**RE: Division Docket No. D-25-15 - The Narragansett Electric Company d/b/a  
Rhode Island Energy 2025 Vegetation Management Standards and Practices  
Responses to Advocacy Section Set 1**

The Narragansett Electric Company  
d/b/a Rhode Island Energy  
Division Docket No. D-25-15  
In Re: Vegetation Management Standards and Practices  
Responses to the Advocacy Section's First Set of Data Requests  
Issued July 2, 2025

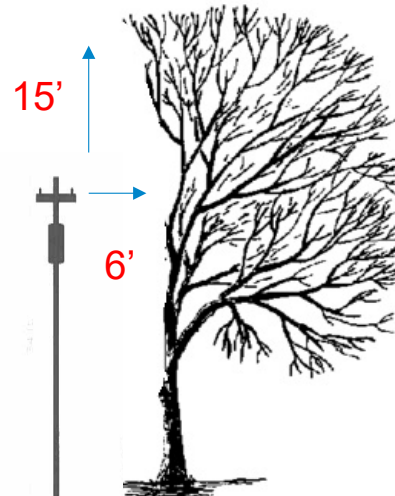
The diagrams do not indicate the reference point for clearances. Please provide enhanced diagrams to illustrate the actual clearance zone.

Please see Attachment AS 1-45.
